Project	<b>IEEE 802.16 Broadband Wireless Access Working Group</b> < <a href="http://ieee802.org/16">http://ieee802.org/16</a> >	
Title	<b>Fixes for Network Entry Flow Charts</b>	
Date Submitted	<b>2006-11-16</b>	
Source(s)	Nadav Lavi et al Alvarion Ltd. [Address Line 1] [Address Line 2]	Voice: +97236457834 Fax: [Fax Number] <a href="mailto:Nadav.lavi@alvarion.com">[mailto:Nadav.lavi@alvarion.com]</a>
Re:		
Abstract	Fixes for Network Entry Flow Charts in 802.16e	
Purpose	For the review in 802.16 Maint TG	
Notice	This document has been prepared to assist IEEE 802.16. It is offered as a basis for discussion and is not binding on the contributing individual(s) or organization(s). The material in this document is subject to change in form and content after further study. The contributor(s) reserve(s) the right to add, amend or withdraw material contained herein.	
Release	The contributor grants a free, irrevocable license to the IEEE to incorporate material contained in this contribution, and any modifications thereof, in the creation of an IEEE Standards publication; to copyright in the IEEE's name any IEEE Standards publication even though it may include portions of this contribution;

**Figure 67-Handling SBC-REQ**

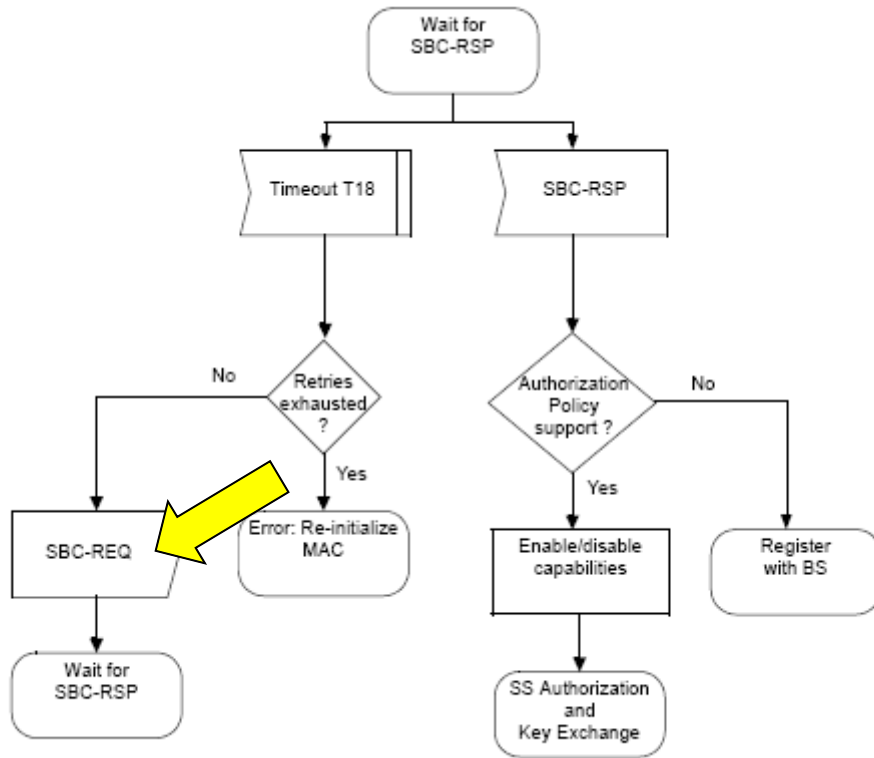
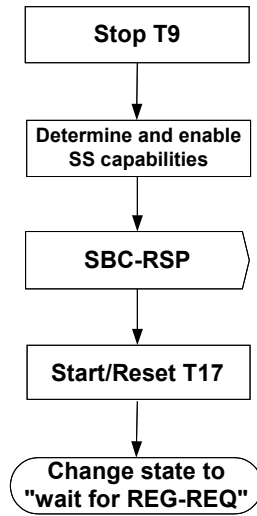
1. There is an unclear definition of how to handle expiration of T9 in the BS side in SBC transaction, and expiration of T17 in the BS side in REG transaction. The condition for “Release and age-out connections” is unclear and not well defined. In addition, this action is local to the BS and thus remains unknown to the SS. We suggest that the BS would send unsolicited RNG-RSP message with Abort instruction when these timers expire.
2. The current Network Entry flow chart cannot handle retransmission, either due to processing delays or message drop. After the BS transmits a response message, it will proceed directly to the next state in the Network Entry flow and thus cannot handle a retransmission of request by the SS; this would cause the Network Entry procedure to end in failure. For example, the following flow chart (Figure 67 in 802.16e-2005) shows that BS sends SBC-RSP.

Replace Figure 67 in 6.3.9.7 with the following figure:

**Figure 70 – Handling REG-REQ**

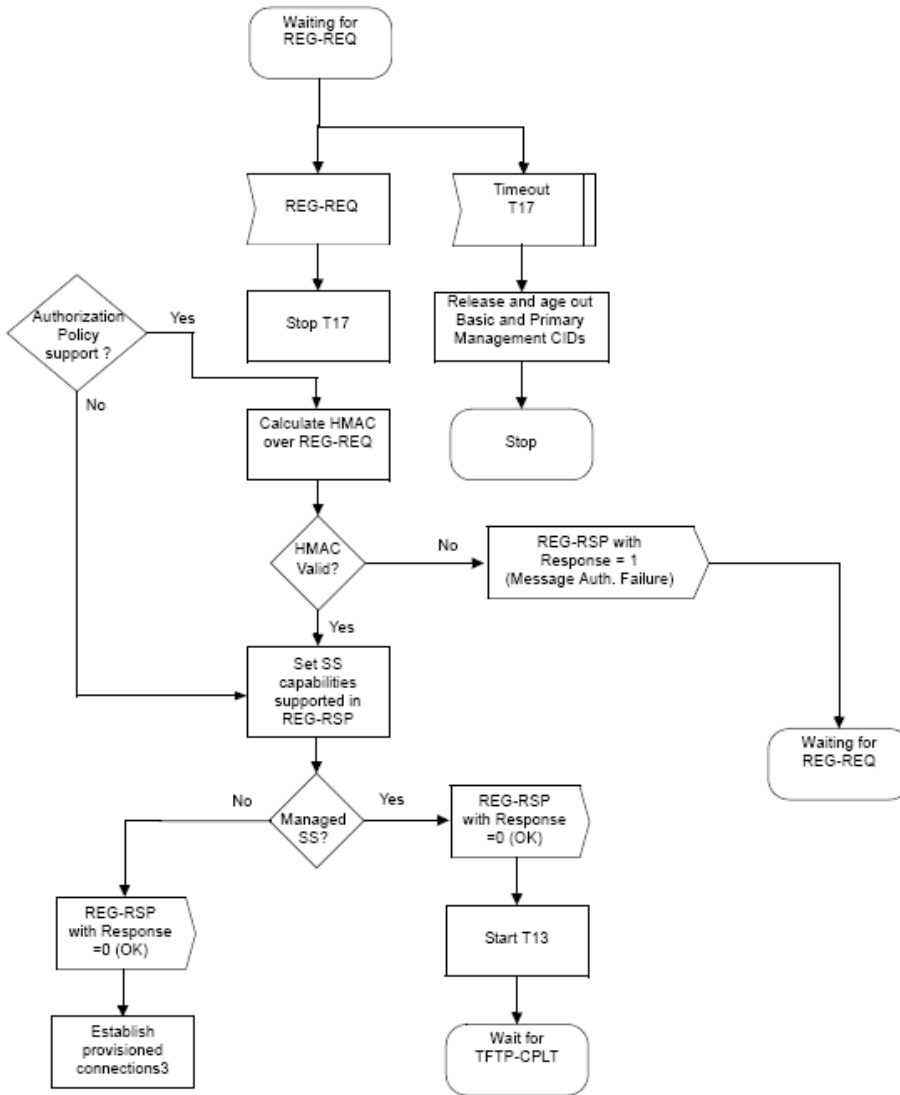
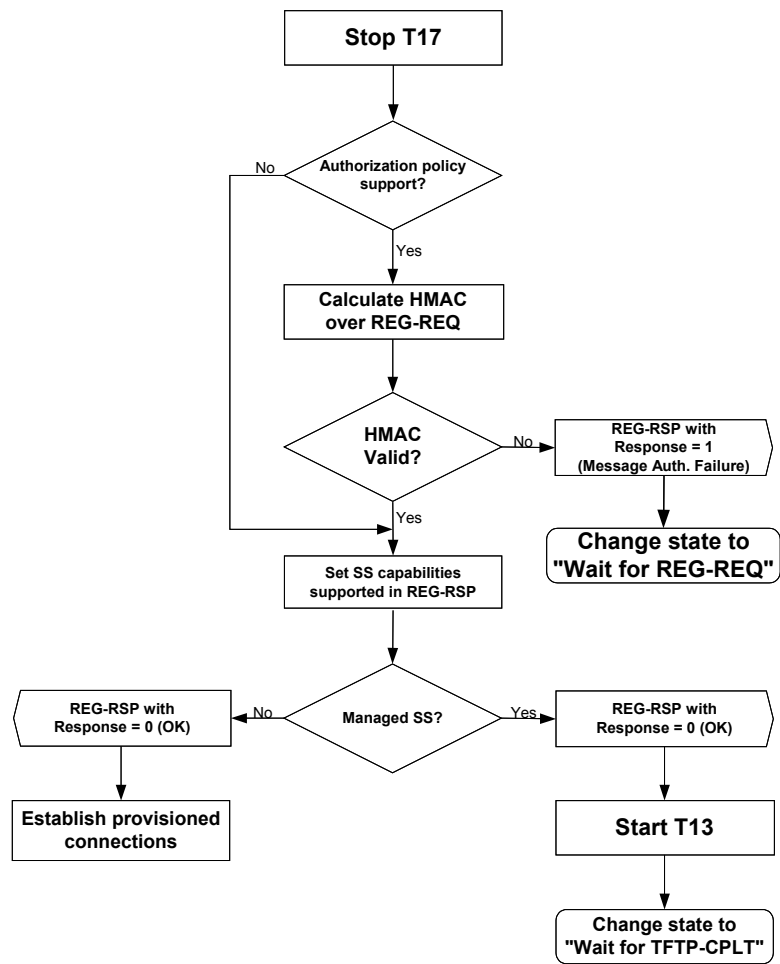
However after sending SBC-RSP, the BS proceeds directly to the registration step. The corresponding flow chart (Figure 70) does not contain any state where a retransmission of SBC-REQ can be received and processed. This is just an example of one single scenario. Similar failures can be identified for other steps in the entire Network Entry flow.

Replace Figure 70 in 6.3.9.9 with the following figure:

**Figure 68 – Registration – SS**

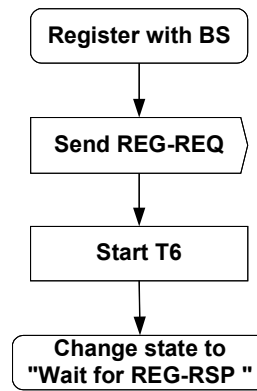
*Replace Figure 68 in 6.3.9.9 with the following figure:*

**Figure 69 – Handling REG-RSP**

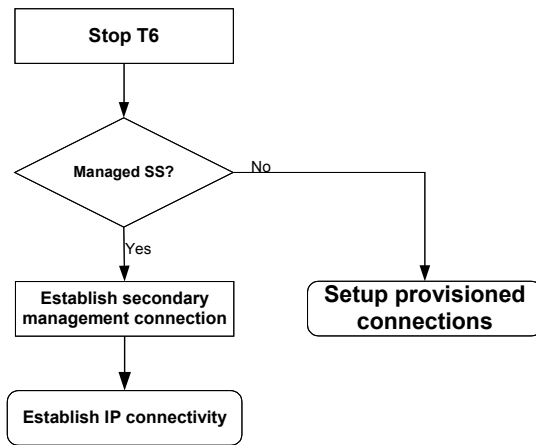
*Replace Figure 69 in 6.3.9.9 with the following figure:*

**Figure 66 – Handling SBC-RSP**

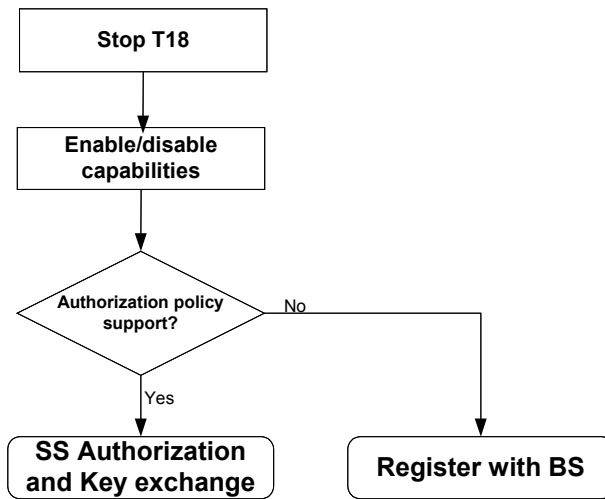
If the SS does not receive SBC-RSP within T18 timeout, it will retransmit the SBC-REQ (Figure 66).

Replace Figure 66 in 6.3.9.7 with the following figure:

Figure X – Network entry state-machine BS side (\* Applies only to OFDMA)

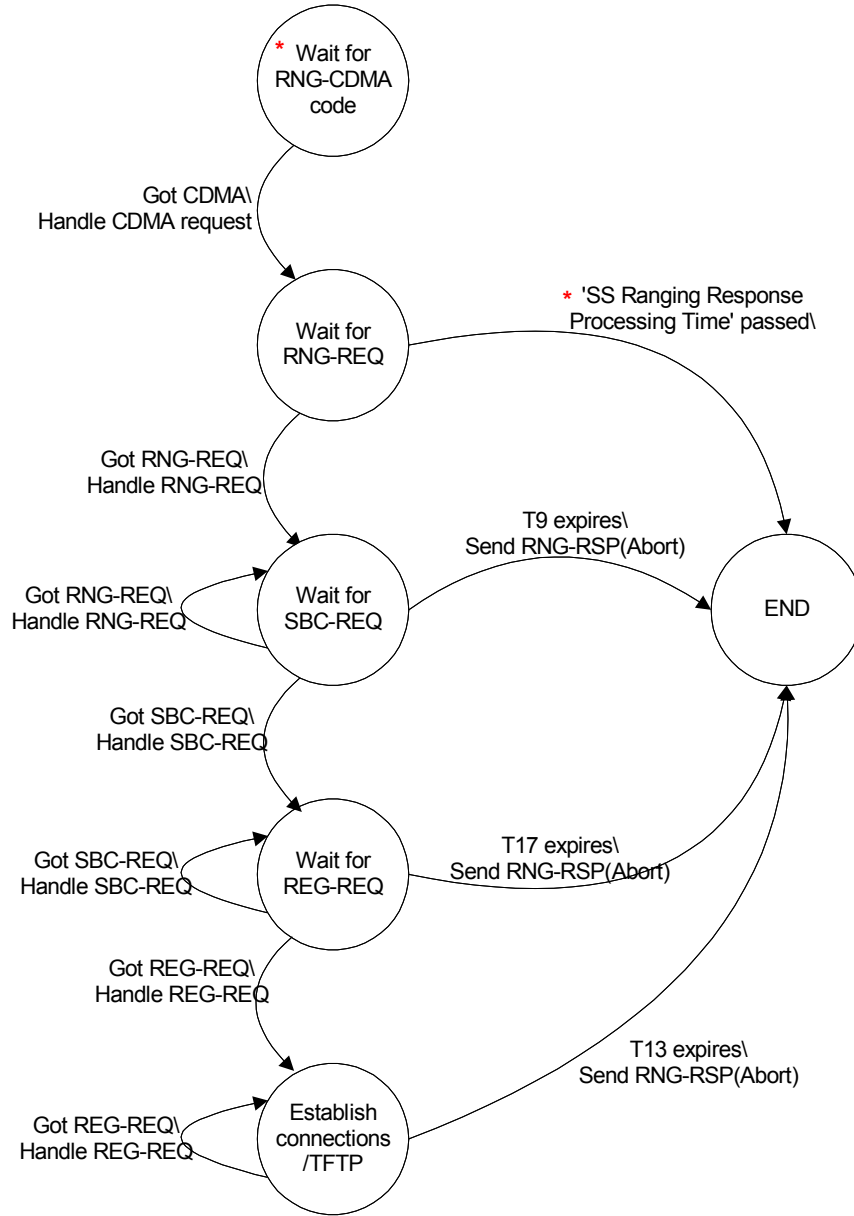
We suggest the Network Entry process be specified using 1) Network Entry state machine, and 2) set of actions/procedures of handling the Network Entry messages. This will provide a clearer definition of the network entry procedure as well as the handling of error/failure conditions.

Add the following Figure:
